INSPECTION REPORT

5912 9th Street, NW Washington, DC 20011

SQUARE: 2986 LOT: 0025

Devices not sealed at penetration of horizontal membrane

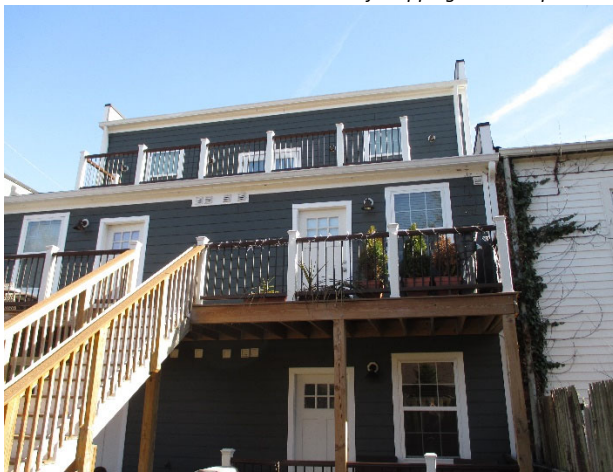
1. The fire partitions are not continuous.
2. The annular space is not properly sealed for devices that penetrate this fire rated membrane.
3. Insulation has been installed around HVAC ducts penetrating the rated assembly.
4. Proper dampers are not installed at air transfer openings throughout.

Box used for lighting

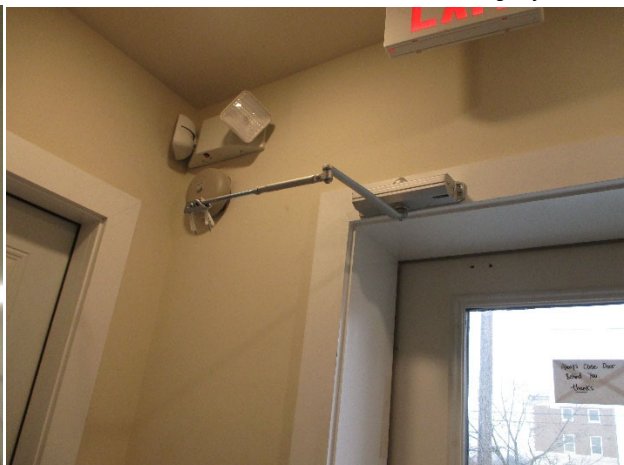
The recessed light fixtures are not installed correctly. The round boxes (B520A) used to hang these fixtures are properly rated for a 1-hour assembly, however, the UL listing states that "No box shall be located within 4-5 feet of another box".

The luminaire in this case is used as a surface mount fixture, not the retro fit type stated and it is not compliant. (see Attachments 4 & 5). The L-TECH Corporation specification sheet obtained from their website states: "LED disc light for square or octagonal junction boxes". The boxes used in this assembly are round and the amount of box fill is questioned. (see Attachment 6)
